ADDENDUM No. Three (3)

IFB No. 2021-202

CONSTRUCTION, ROOF REPLACEMENT, COLLIN COUNTY 900 BUILDING

ADDENDUM NUMBER ONE

R1.01
Sheet No.

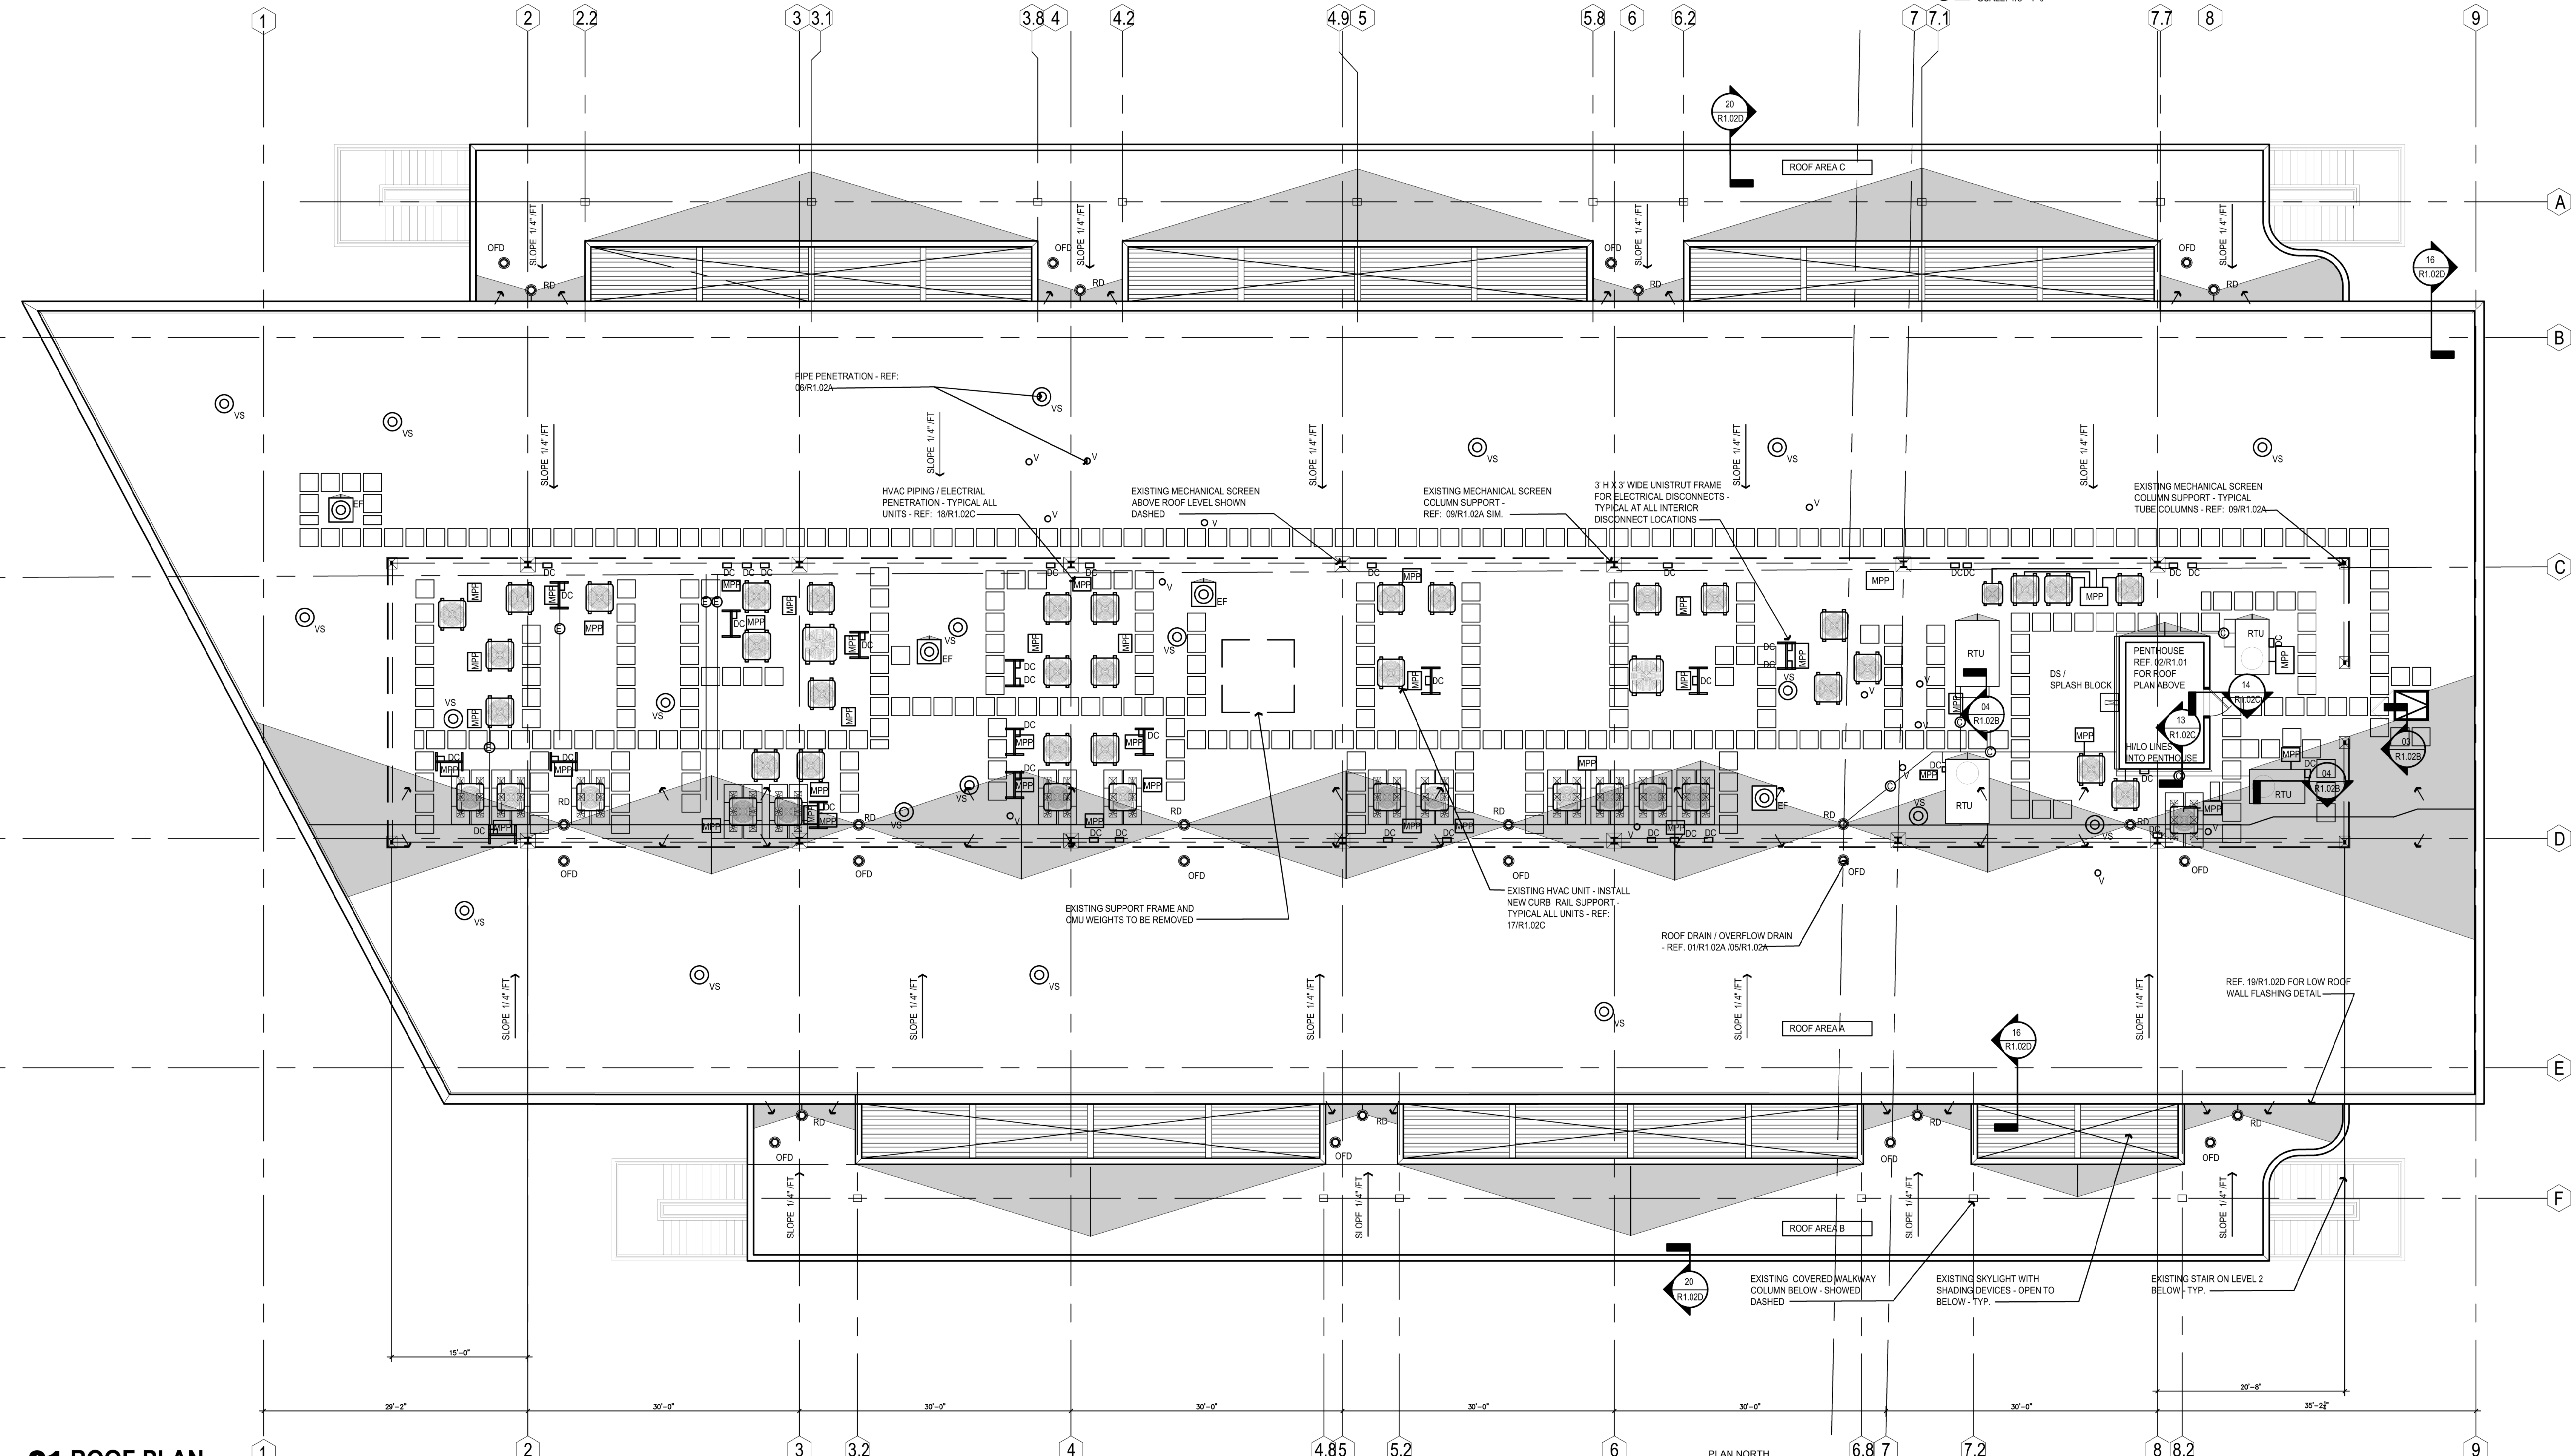
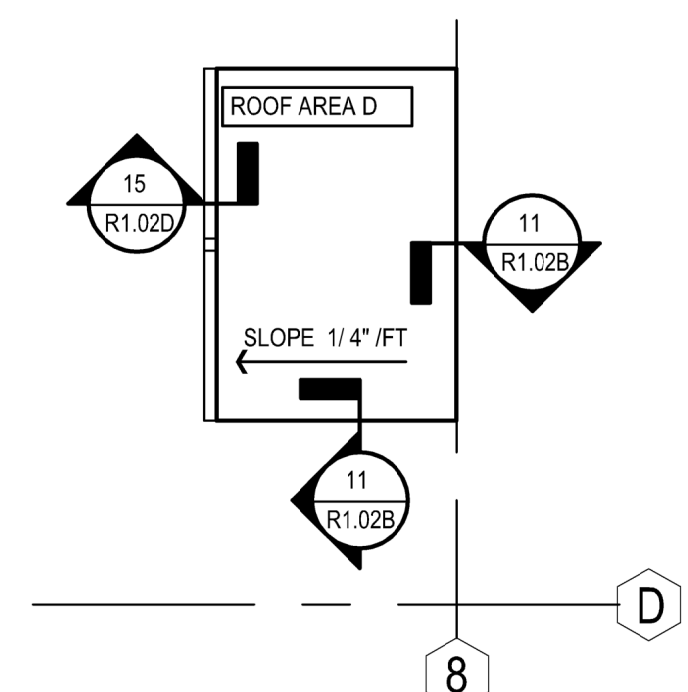
- 1) 1 page of written text.
 - a. Due to dramatic price fluctuations in low-rise foam adhesives, at the contractor's option, the following alternate system to that specified in Section 07 54 19 is acceptable:
 - i. PVC membrane fully adhered over 1/4" DensDeck Prime, mechanically attached (gang fastened) through both layers of rigid insulation to LoadMaster Deck. Rigid insulation thickness is 4.5 inches.
 - b. All other aspects of the project are to remain unchanged.

- 2) 1 Drawing Sheet:
 - a. Sheet R1.01 Roof Plan
